TVA-BFN-TS-441

**BROWNS FERRY NUCLEAR PLANT (BFN) - UNITS 2 and 3 - TECHNICAL SPECIFICATIONS (TS) CHANGE TS-441 - UPDATE OF PRESSURE-TEMPERATURE (P-T) CURVES**

#### PROPOSED TECHNICAL SPECIFICATIONS (TS) CHANGE TS-441 TVA EVALUATION OF PROPOSED CHANGE

**Figure 3.4.9-2**  
**Pressure/Temperature Limits for**  
**Reactor In-Service Leak and Hydrostatic Testing**

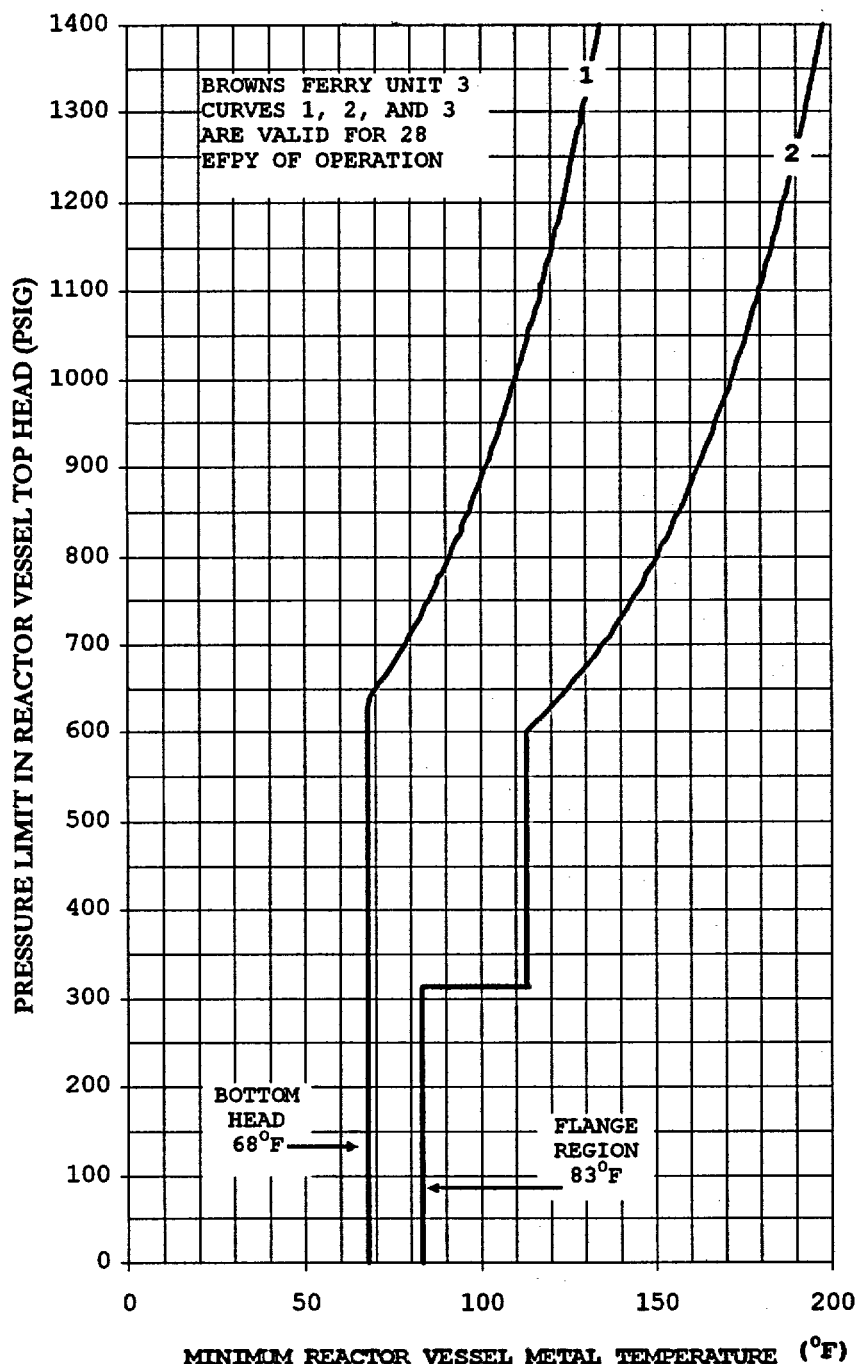
These pages are submitted for NRC review and approval, however, they will not be placed into the BFN TS at this time. As Unit 2 approaches 23 EFPY, and as Unit 3 approaches 20 EFPY, TVA will replace the TS figures shown in Enclosure 3 above with these figures.
